Title: Replacement of exhaust manifold		
AG-SB-2023-02-B-EN	Effective Date: 01.04.2023	Compliance Category:
Applicability		A – MANDATORY B – RECOMMENDED C – OPTIONAL
Aircraft type & model: Cavalon 915iS	Affected Serial number(s): All Cavalon 915iS	
The maintenance manual to be referenced is this stated or subsequent issue.		As per AutoGyro website
This form is the response from AutoGyro GmbH either against a problem found in the product in service requiring a containment or rectification action, or as service information for aircraft modification incorporation. For help, contact airworthiness@auto-gyro.com.

Illustrations

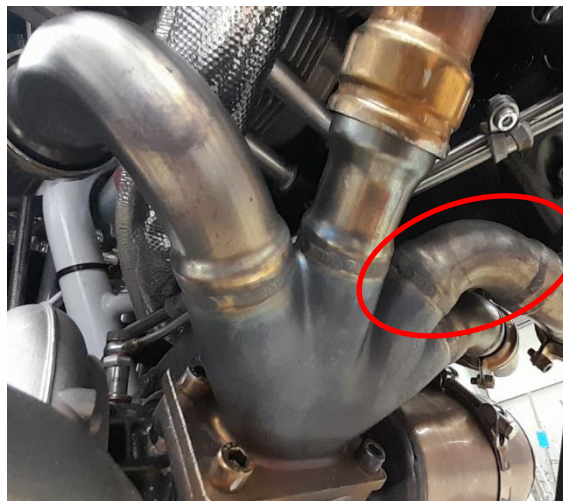
A number of early generation Rotax 915iS exhaust manifolds were found to have cracked in service. This early generation was superseded in 2021 by a new design, shown in service to be reliable.

The difference between both versions is an improved welding at the exhaust connection from cylinder two.

The exhaust manifold is changed in accordance with the Rotax engine maintenance manual.

The manifold is Rotax part number 979563.
AutoGyro provides a kit containing the required service components, part no. 48658, available from the AutoGyro on-line shop.
